REMARKS

Appln. No. 10/586,386

ANNOTATED SHEET

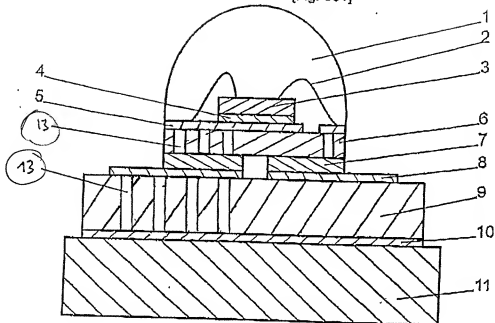
The drawings were objected to under 37 C.F.R. § 1.83(a) for allegedly failing to show every feature of the invention specified in the claims. In particular, the 'through-contacts' were deemed not shown in the drawings. Submitted herewith is an Annotated Drawing sheet showing changes to Figs. 1 and 3, as well as a Replacement Sheet of drawings incorporating the changes to Figs. 1 and 3. On the Annotated Sheet the reference numerals corresponding to changes to the drawings have been circled. In annotated Fig. 1, through-contacts 13 have been added. In annotated Fig. 3, through-contacts 13 and the insulation layer 14 have been added. Applicant submits that the amendments to the drawings add no new matter to the original disclosure, and support for the amendments may be found in the original specification (*see*, for example, paragraph [0019] with respect to the through-contacts). Approval of the amended drawings is respectfully requested. Applicant submits that the drawings are in compliance with 37 C.F.R. § 1.83(a) and that the objection has been obviated. Withdrawal of the objection is therefore respectfully requested.
